Project Name:	Land at Bayards, Eastergate (Miller Homes)
Document Reference:	091.5016/SVR/2.2
Document Name:	SuDS Verification Report – Area 2
Prepared By:	Samuel Flesher
Checked By:	Meagan Weedon
Approved By:	Jon Soar

- 1.1 This Sustainable urban Drainage Strategy (SuDS) Verification Report – Area 2, has been prepared by Paul Basham Associates on behalf of Miller Homes to support the 'As-Built' verification report to Arun District Council in relation to Land at Bayards, Eastergate.

- 1.2 This Verification Report has been prepared to support the discharge of Planning Condition 24. The report authors are Paul Basham Associates Ltd. Paul Basham Associates were established in 2009 and are a multi-disciplinary Transport Planning, Civil and Structural Engineering Consultancy, employing a team of Civil Engineers.

Figure 3: SDS GEOLight Cross Section

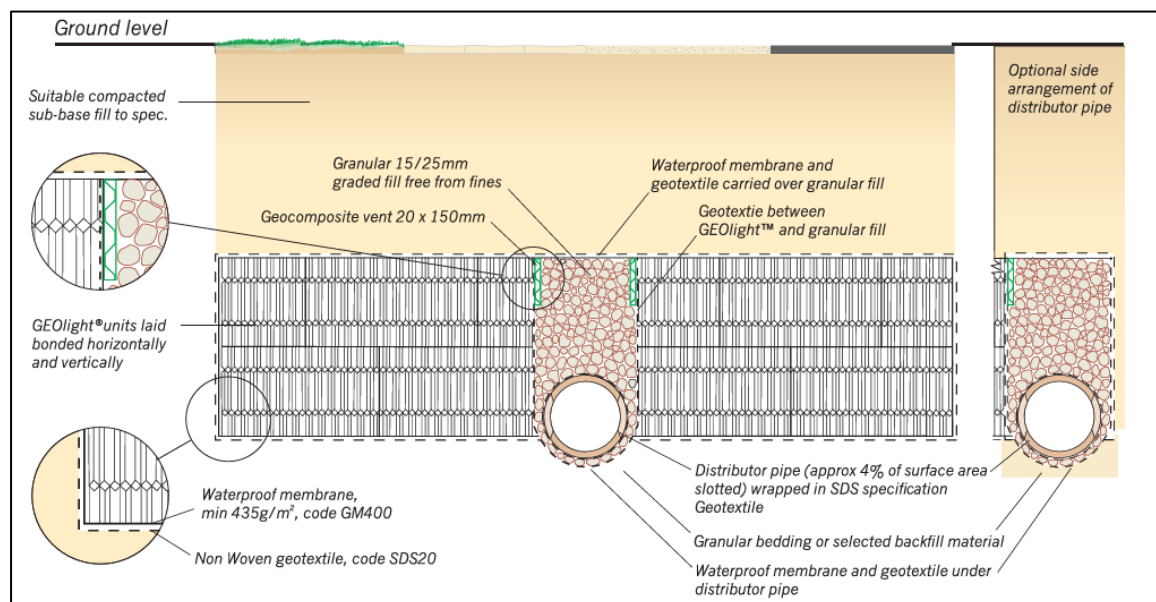
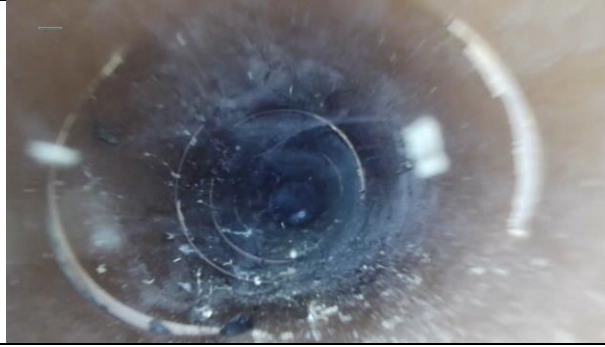
- 4.5 From the images it appears that the installation of the geotextile membrane are not installed and sealed in accordance with the manufacturer's specifications.
- 4.6 Where the images do not show the crates systems uncovered, we were unable to determine if sufficient storage was included.
- 4.7 The SDS GEOLight system appears to have been substituted and installed in this area. This product typically requires a specific arrangement, including a perforated pipe running centrally through the attenuation crates, as illustrated in **Figure 3** below.

However, the contractor has instead installed an in-situ pipe that has been hand-cut with spiral slits to function as a perforated pipe, intended to feed water into the crates. This pipe appears to have been installed without appropriate bedding.

Furthermore, the structural integrity of the pipe has likely been compromised due to the hand-cut slits, which is also evident from the CCTV footage. There also appears to be no restraint preventing the pipe from shifting or rotating. As a result, there is no assurance that the slits will remain correctly oriented (i.e. facing downward towards the crates).

This may lead to ineffective interaction between the pipe and the attenuation system, potentially causing the drainage to perform in an unintended and unpredictable manner. will face down towards the crates therefore resulting in a non-compatible interaction that may cause the drainage to act in away that is unexpected.

- 7.1 The air vent to the Soakaways requires investigation and resolution.
- 7.2 The remedial works carried out within Area 2 is as listed below:
- The Contractor shall obtain written approval from crate supplier that the constructed soakaways comply with their specification. Notwithstanding this requirement, it is recommended that all damaged or deformed pipes be removed and replaced.
 - Install additional infiltration crates where the storage volume is less than what was specified in the approved design or provide supporting hydraulic modelling to support the as-built storage.
 - Once remedial works have been carried out the system will need to be re-CCTV surveyed.

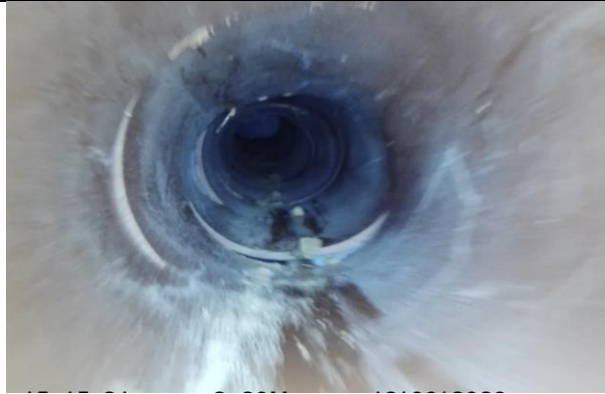
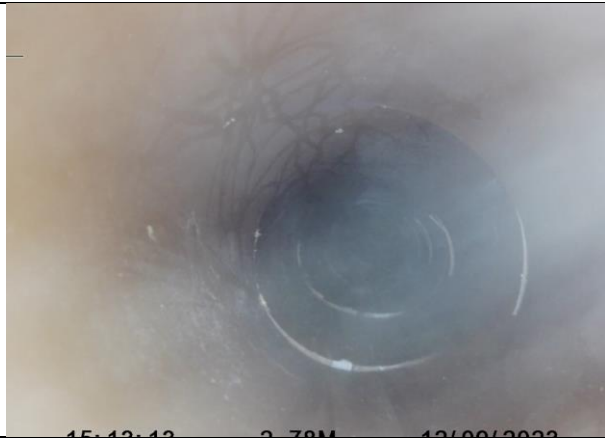
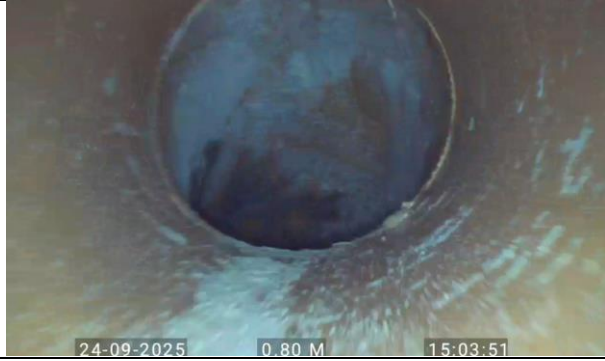
Ref	Defect Images	Comments
PS216-PSCP217		Imagery very blurry and camera light appears to be dim. Appears to be no defects to the pipe
PSCP217-SA50		Pipe has snapped at the point where pipe rests on crates.
PS209-PSCP210		Imagery very blurry and camera light appears to be dim. Appears to be no defects to the pipe
PS210-SA66-67		Connection into side of infiltration crate, appears to be PolyStorm crate unit. Membrane is slightly protruding into pipe. No other visible defects.
PS212-PS213		No major defects
PS213-SA66-67		Pipe with spiral splits shown, pipe has deformed and no longer circular. Pipe also appears to be bent and changes direction without a junction. Drainage approach differs between plots 66 & 67, contractor to confirm if this is correct.
PS5251-S206		Appears to be a small amount of water build up at start of survey due to sediment in the pipe. No other major visible defects.

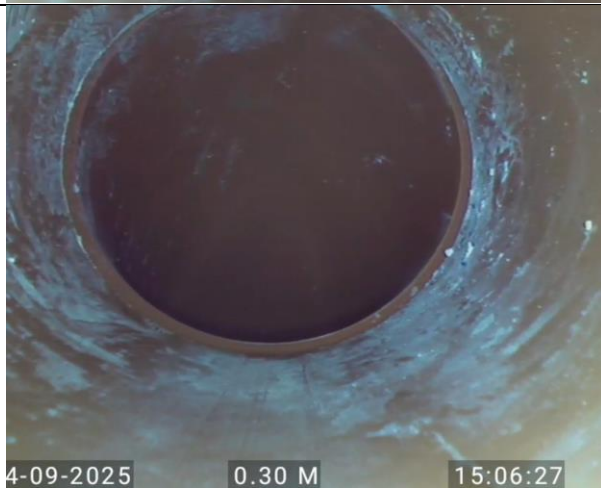
S206-SA64-SA65		Pipe with spiral splits shown, pipe has deformed and no longer circular. Pipe also appears to be bent and changes direction without a junction.
PS202-PSCP203		No visible major defects
PS203-SA64-65		Pipe with spiral splits shown, pipe has deformed and no longer circular. Pipe also appears to be bent and changes direction without a junction.
PS221-PSCP220		No visible major defects
PSCP220-SA53		No visible major defects, pipe run appears to end in a bend into the top of crate system
PS54-PSCP220		No visible major defects
PS344-PSCP342		Footage starts at -10m and shows a pipe bend at 0m the 4.7m upstream of PSCP342. No joint for rainwater pipe.
PS342-SA57-63	Footage not provided

PS5281-PS61		Footage shows a pipe junction, design shows no junction into this pipe.
PS61-SA57-63		Pipe appears to run into the top of the crates with a bend at the end of the pipe.

PBA Drawing No. 091.5016.0501 Revision C08

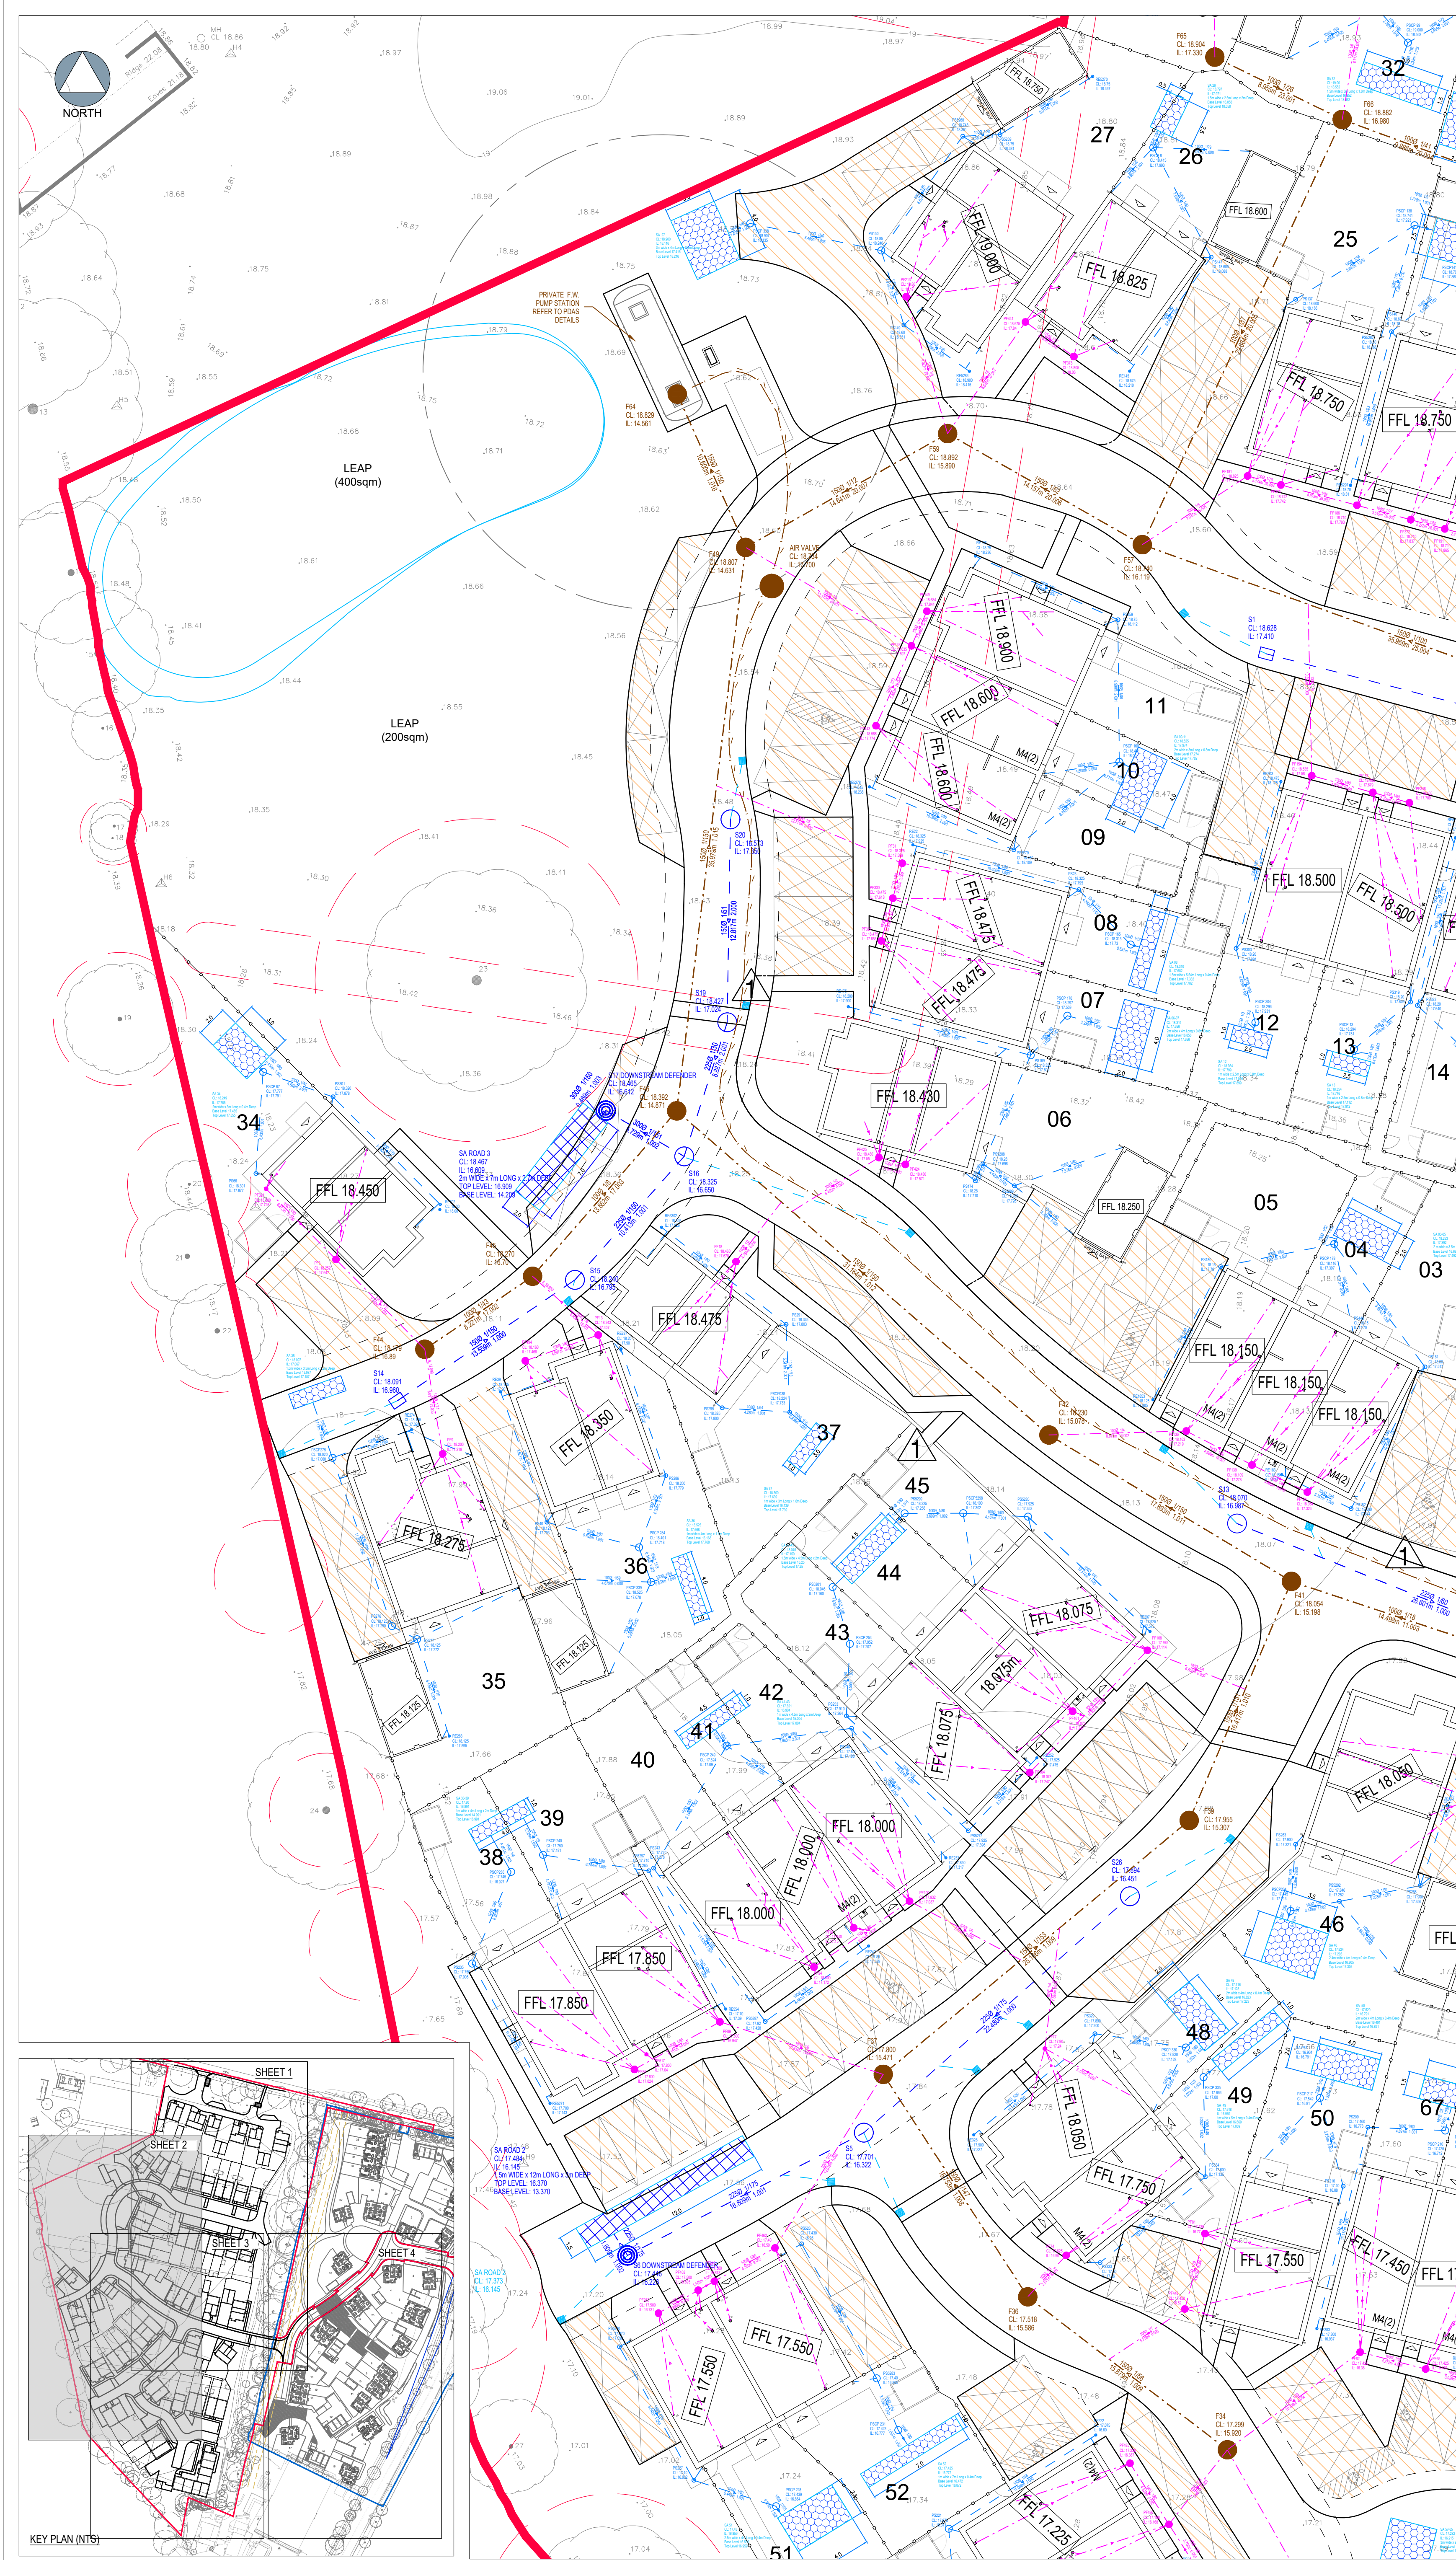
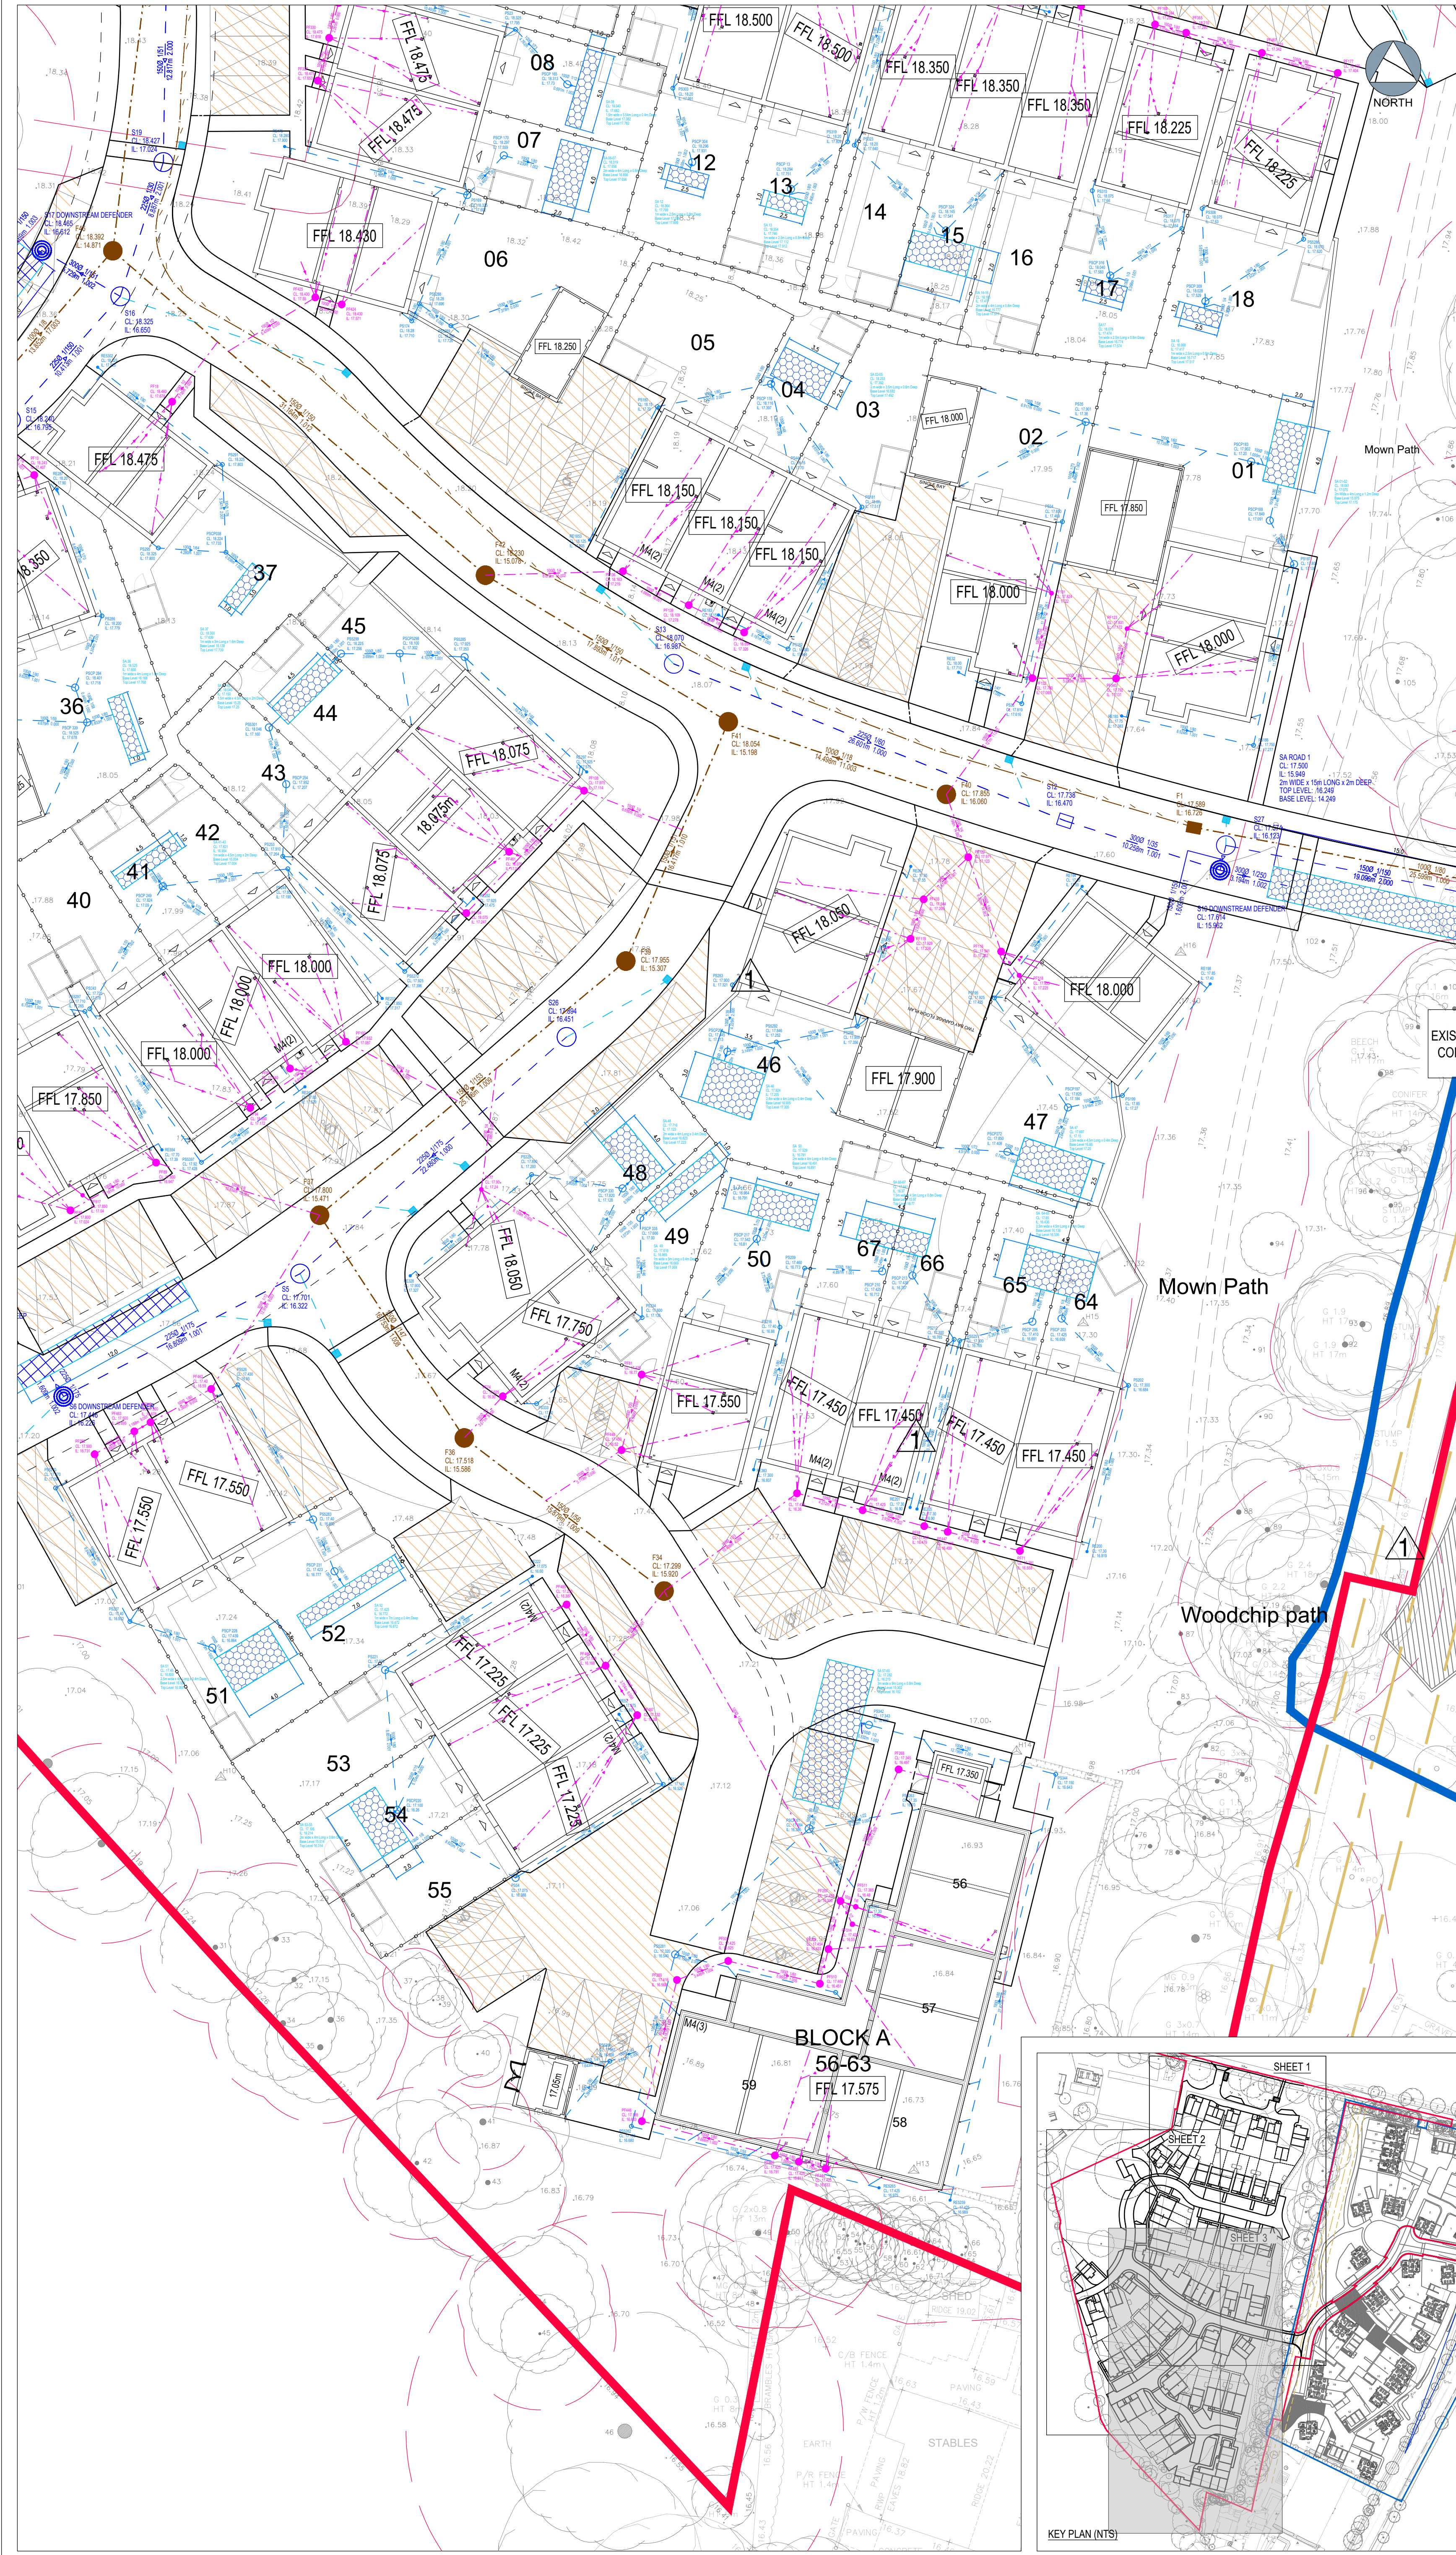
- 3.1 As-Built surveys of the site area and drainage systems have been carried out and the surveys are included as **Appendix C**.
- 3.1 These levels have been reviewed against the design levels shown in 091.5016.0501 C08, 091.5016.0502 C05 and 092.5016.0503 C06 the design drawings can be found in **Appendix B**
- 3.2 A tabulated summary of invert levels for chambers constructed within Area 2 is given below.

Area	Ref No	As-Built CL	Design IL	As-Built IL	Comments
2	PS5281A (indicated as N/A on as-built)	17.28		16.57	No level provided on design, however pipe gradient has been shown at 1:80. As-built suggests this to be 1:339 and therefore likely not achieving self cleansing velocities.
2	PSCP61	17.32	16.396	16.38	
2	SA57-65	17.29	16.215	16.22

- 3.3 The comparison between the design and as built levels shown that the invert levels are generally within normal building site tolerances and fall in the correct directions, unless otherwise noted within the comments provided in Table 1 above.
- 3.4 Cross checks of raised invert levels appear to show that no backfalls have been created.
